DATE:	May 7, 2021	CO #:	Five (5)
TO:	Standafer Builders 1178 West Main Street P.O. Box 247 West Liberty, Kentucky 41472	PROJECT:	Estill County Bus Garage Irvine, Kentucky BG# 19-340 RTA 1837
CONTRACT DATE:	November 18, 2019	CONTRACT FOR:	General Construction

**PROPOSED  
CHANGE ORDER****No. 15****TITLE:** PR09-R1: canopy lights**DATE:** 04/29/2021**PROJECT:** Estill Co. Bus Garage

**TITLE:** PR10: re-circuiting for bus power pedestals

**TITLE:** PR 11 Infrared heater relocation

FIRST FLOOR LIGHTING PLAN  
1/8" = 1'-0"

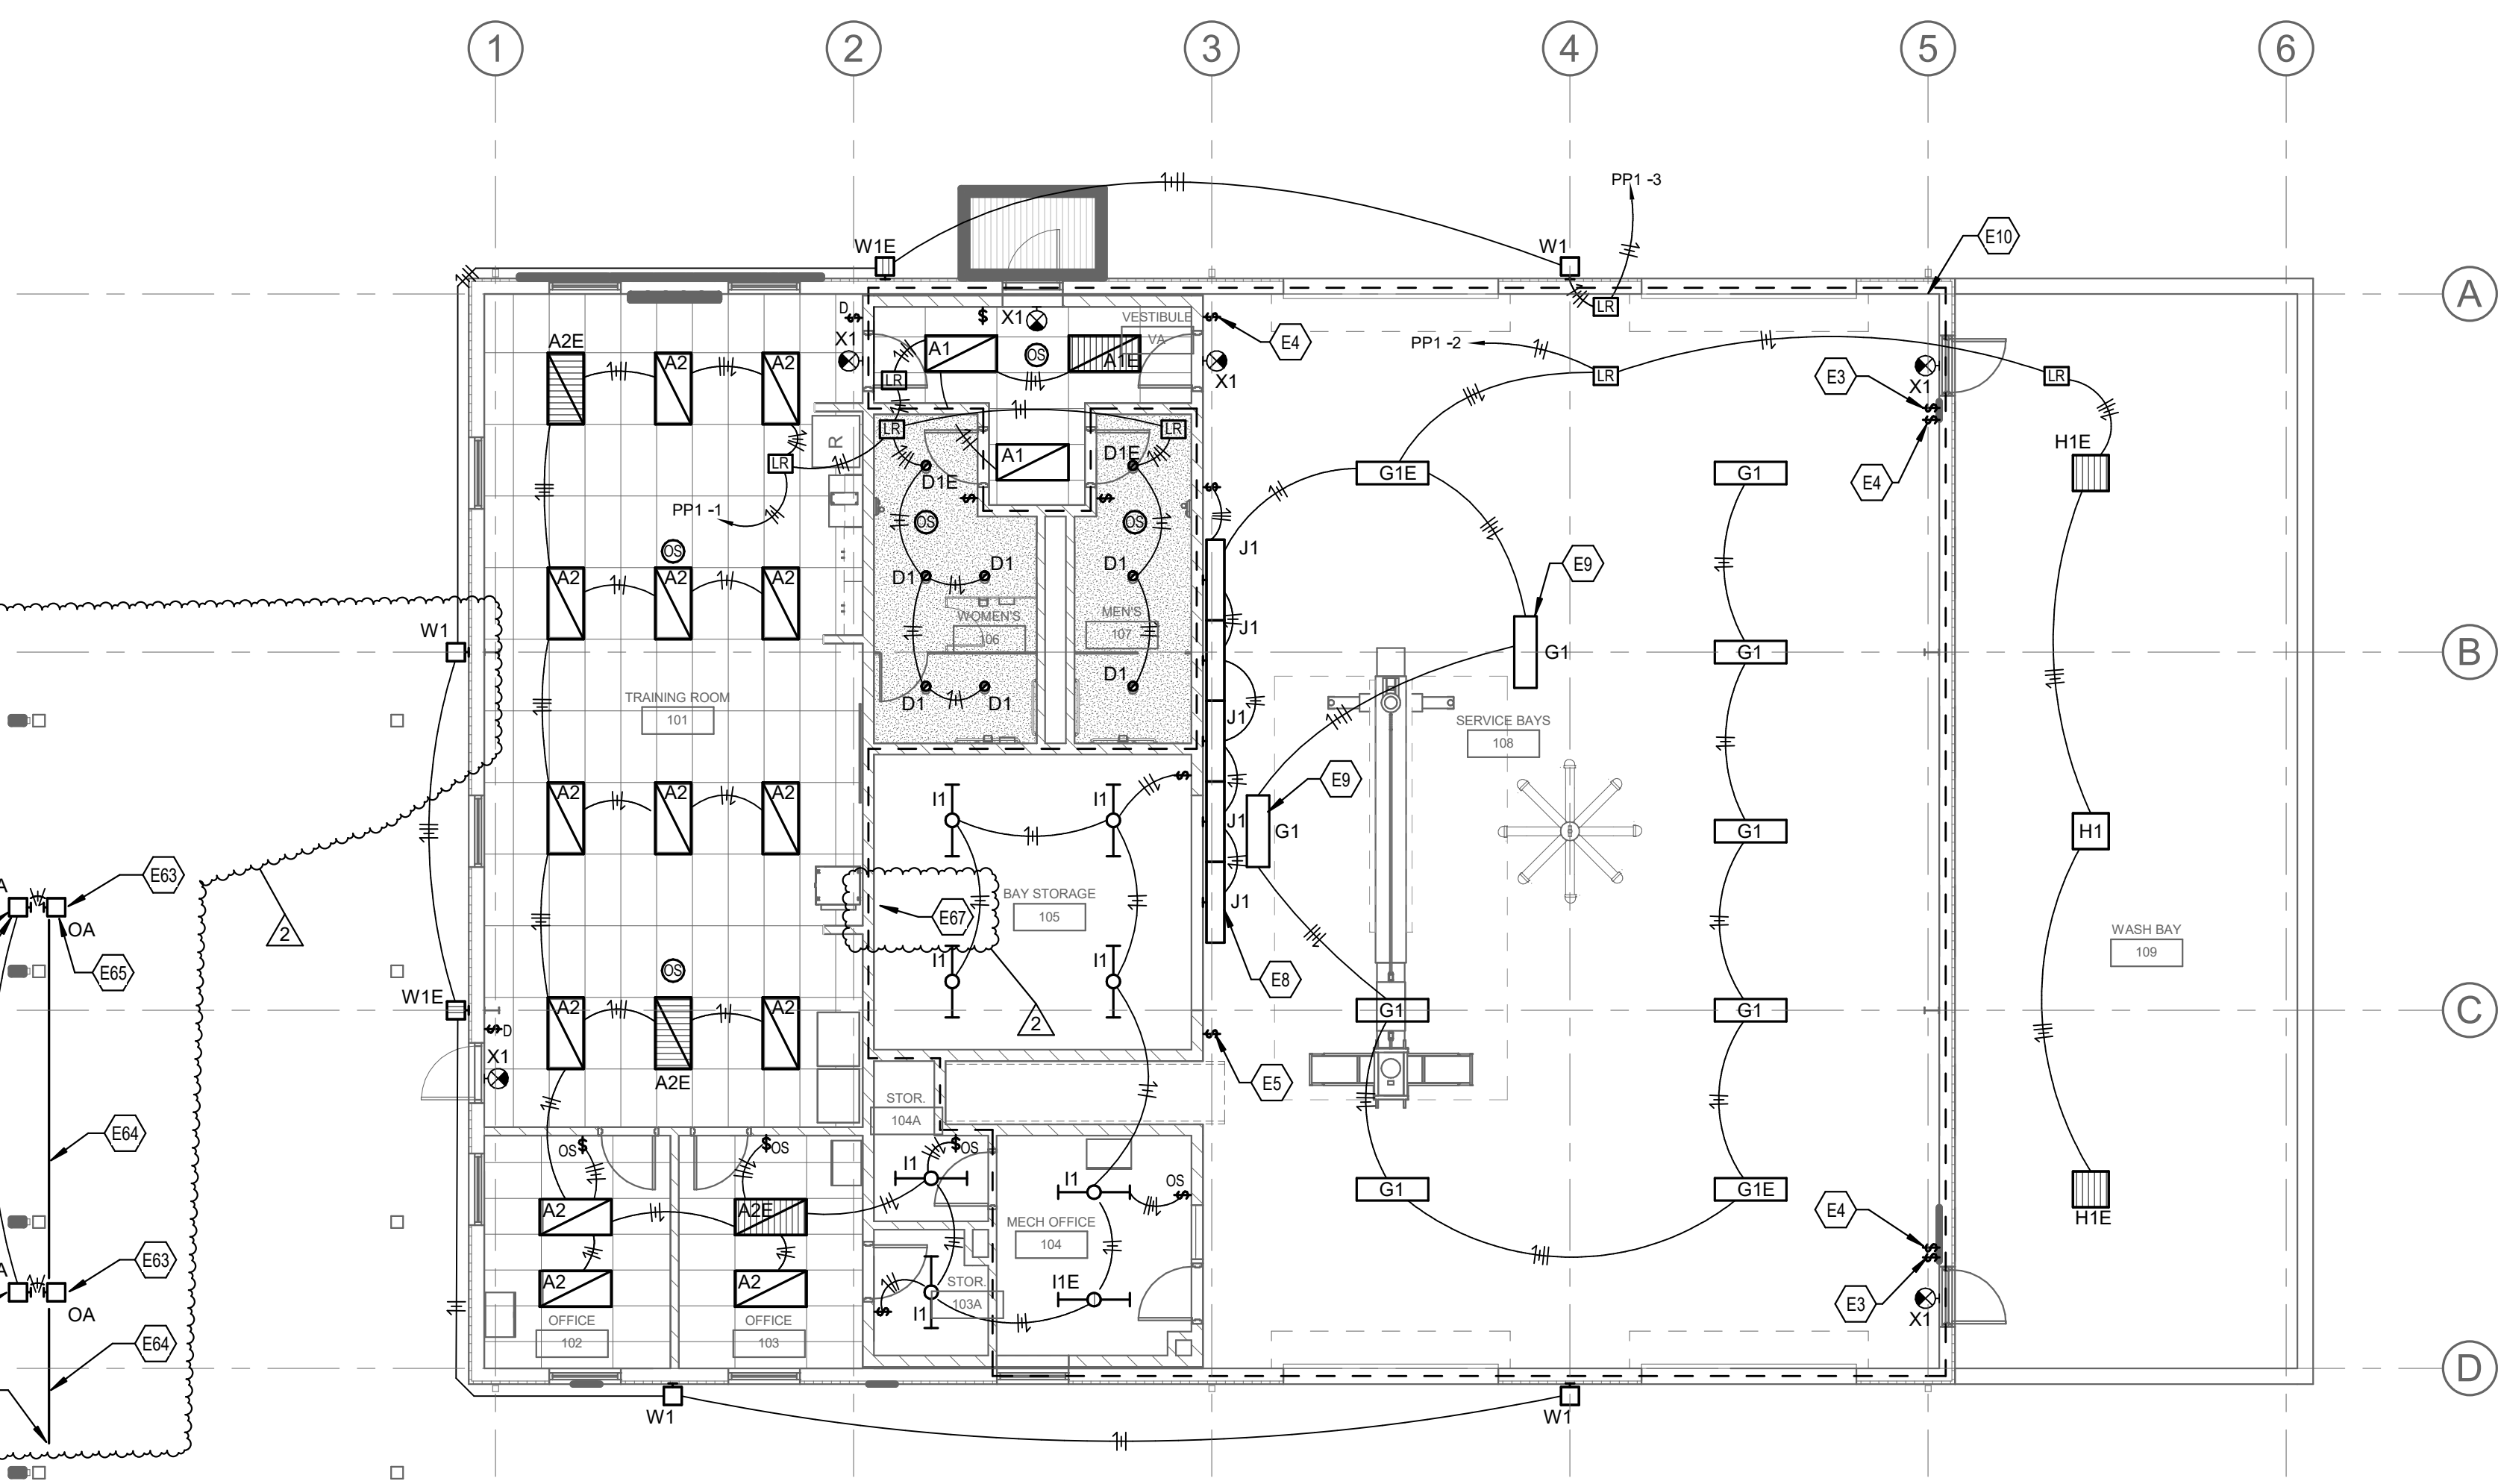
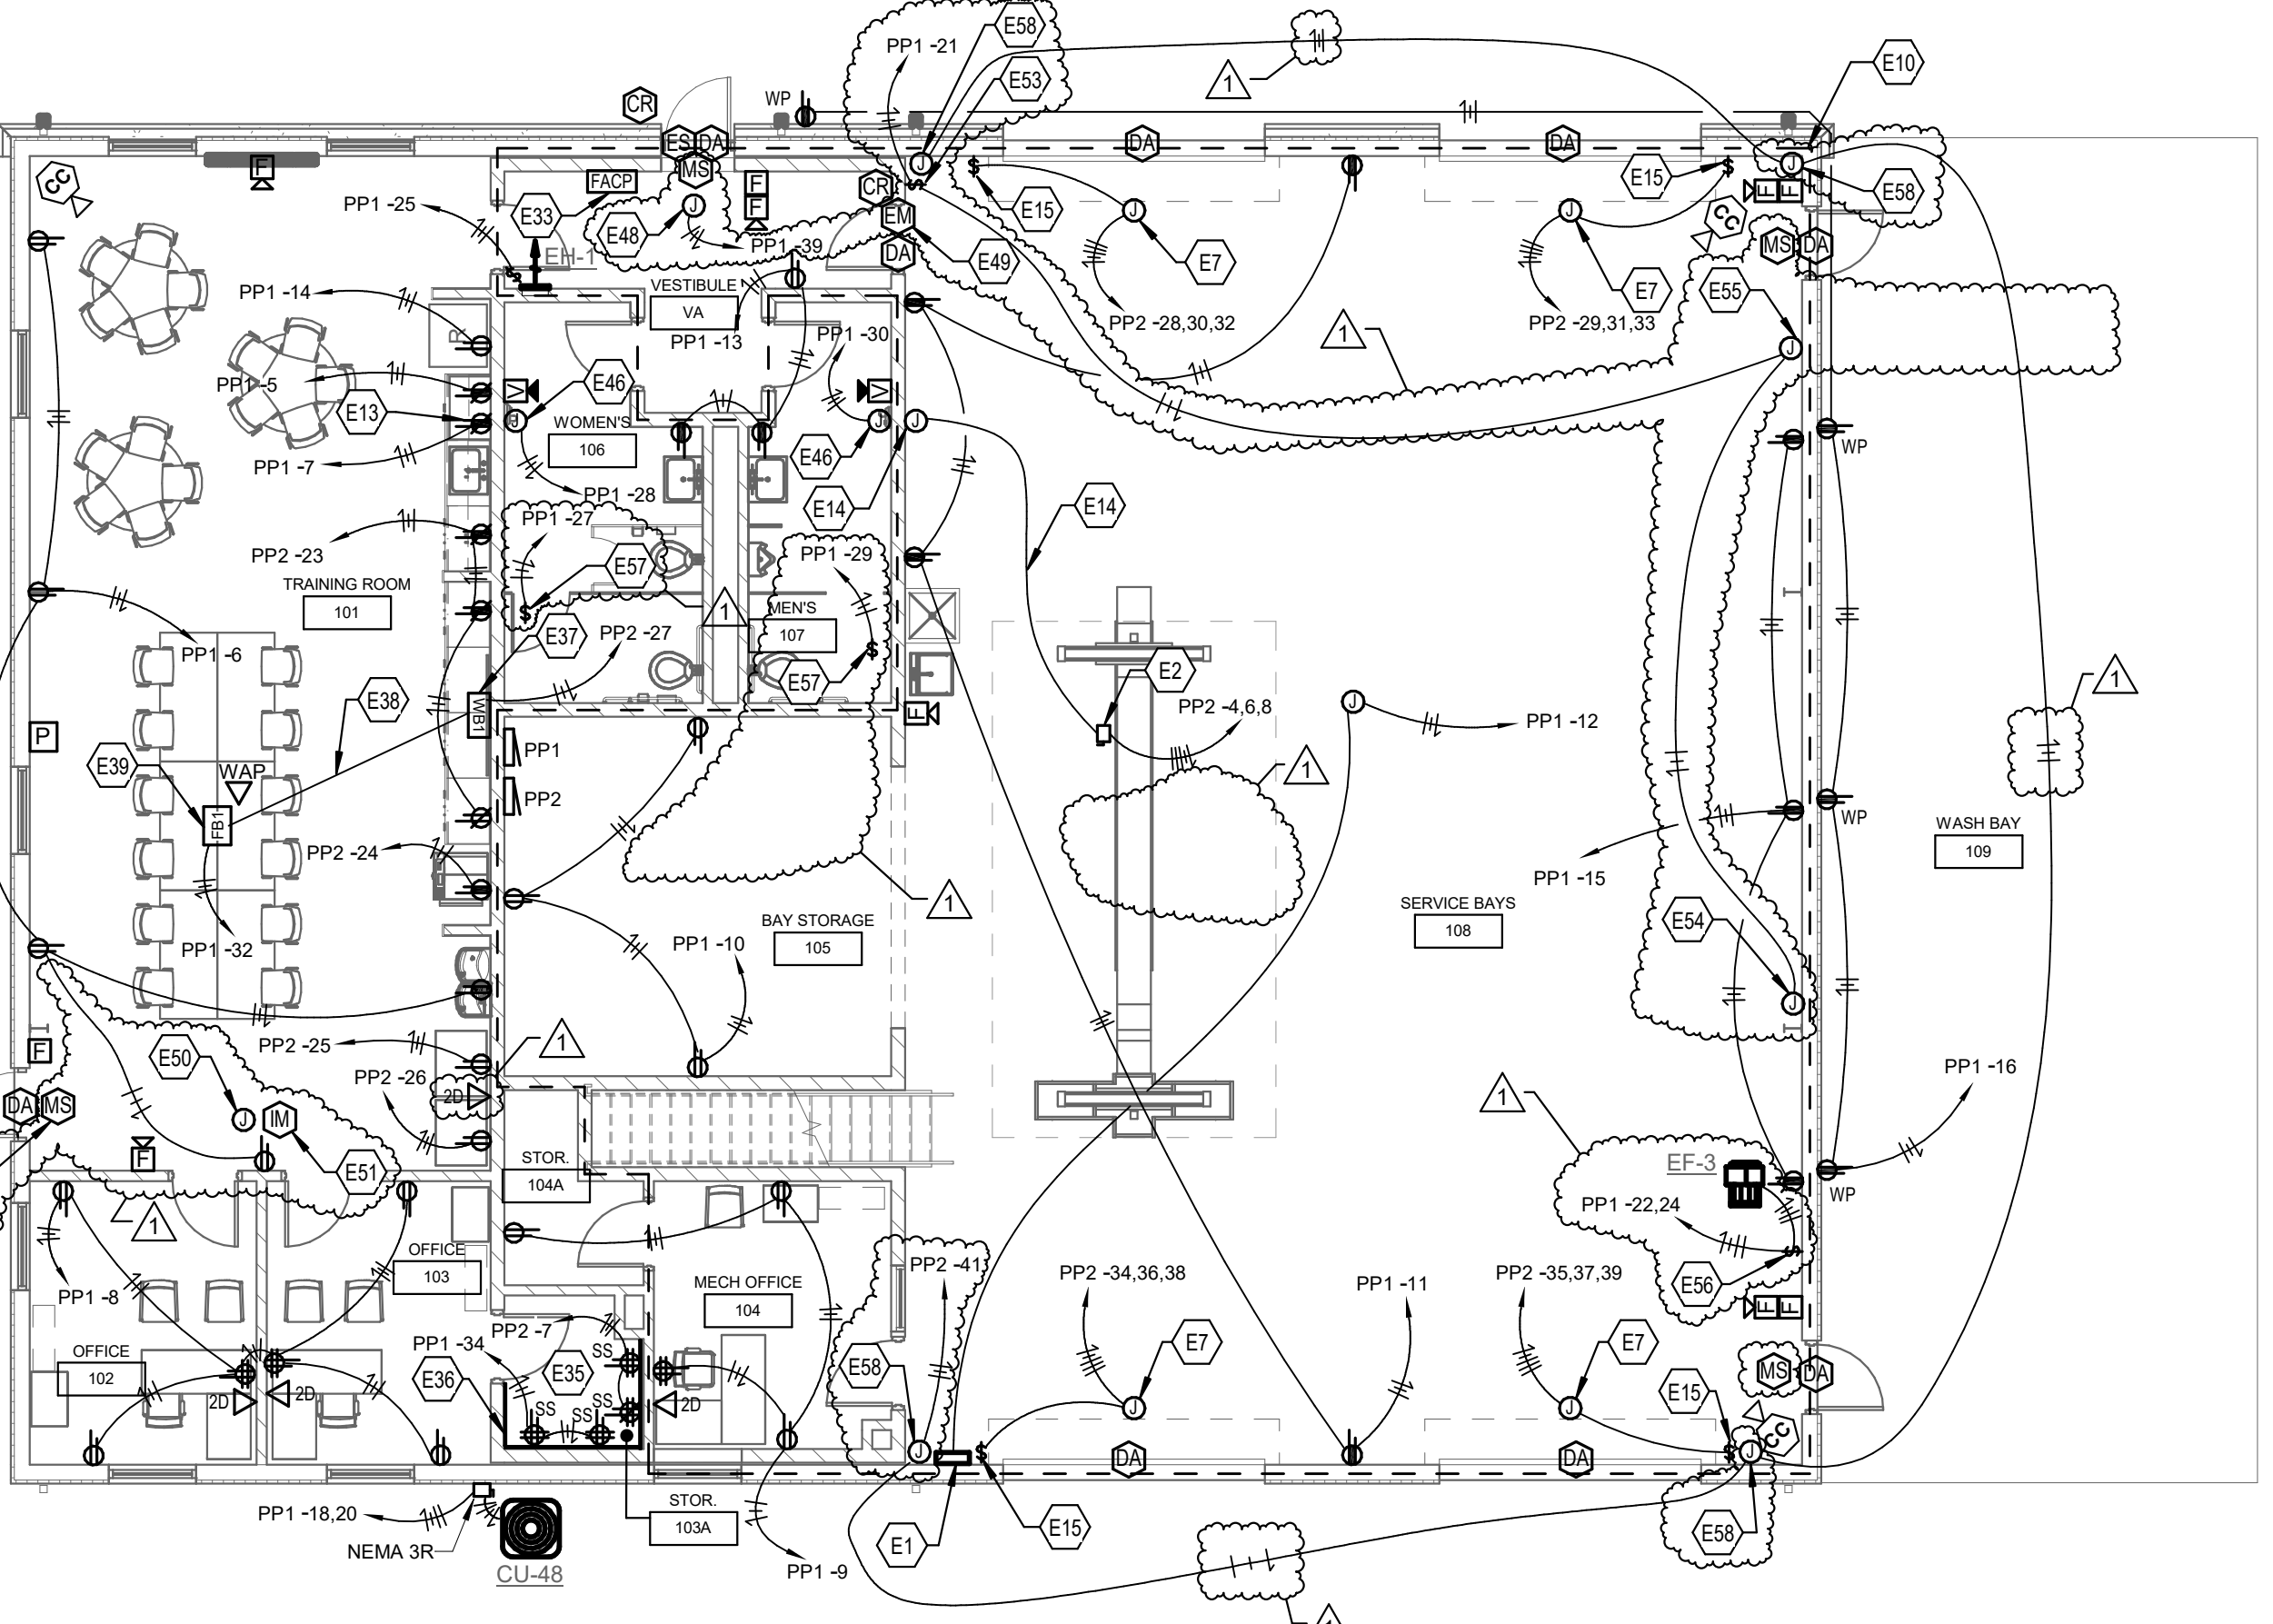
- In accordance with PR 09 and Contractor provided proposed pricing with COP 08, Contractor is to revise the canopy lighting electrical work as indicated within revision cloud on attached drawing E2.0.  
\$5,086.45
- In accordance with PR 10 and Contractor provided proposed pricing with COP 09, Contractor is to provide re-circuiting for bus power pedestals as indicated within revision cloud on attached drawing UE1.0  
\$4,945.00
- In accordance with PR 11 and Contractor provided proposed pricing with COP 10, Contractor is to relocate the bus bay infrared heater.  
\$2,455.66

- We propose labor & materials to install (4) Type OA Fixtures as specified under the fuel canopy as requested
- We will install conduit to bottom of the canopy structure and tie into existing circuit as indicated on PR-09
- We will pull new circuit thru existing conduit as indicated on revised PR-09
- All work will meet NEC 2017

See attached revised PR drawings for the Fuel Canopy Lighting. CMTA has provided this revised drawing which calls out using the spare conductors the owner located in the canopy wire way.

- E63 MOUNT FIXTURE ON SIDE OF CANOPY STRUCTURAL MEMBER.
- E64 ROUTE CONDUITS ALONG CANOPY STRUCTURAL MEMBER, ROUTE INTO FIXTURE JUNCTION BOX. PAINT CONDUITS TO MATCH CANOPY. ALL EXPOSED CONDUITS SHALL BE RIGID STEEL.

- E65 ROUTE CONDUIT OUT BOTTOM OF INSIDE FIXTURE, UNDER STRUCTURE CANOPY, INTO BOTTOM OF OUTSIDE FIXTURE. UTILIZE PULLING ELBOWS.
- E66 ROUTE CONDUIT DOWN COLUMN TO WIREWAY. ENTER BACK OF WIREWAY. INTERCEPT EXISTING SPARE CONDUCTORS FROM PANEL AND EXTEND #12, #12 GROUND TO LIGHT FIXTURES.

- E67 INTERCEPT EXISTING CONDUCTORS TO EXTERIOR WIREWAY. ROUTE CONDUCTOR THROUGH NEW LIGHTING RELAY TO PROVIDE CONTROL OF CANOPY FIXTURES VIA PHOTOCELL ON LIGHTING CONTROLS NETWORK. CONNECT CIRCUIT TO NEAREST UNSWITCHED LIGHTING CIRCUIT.
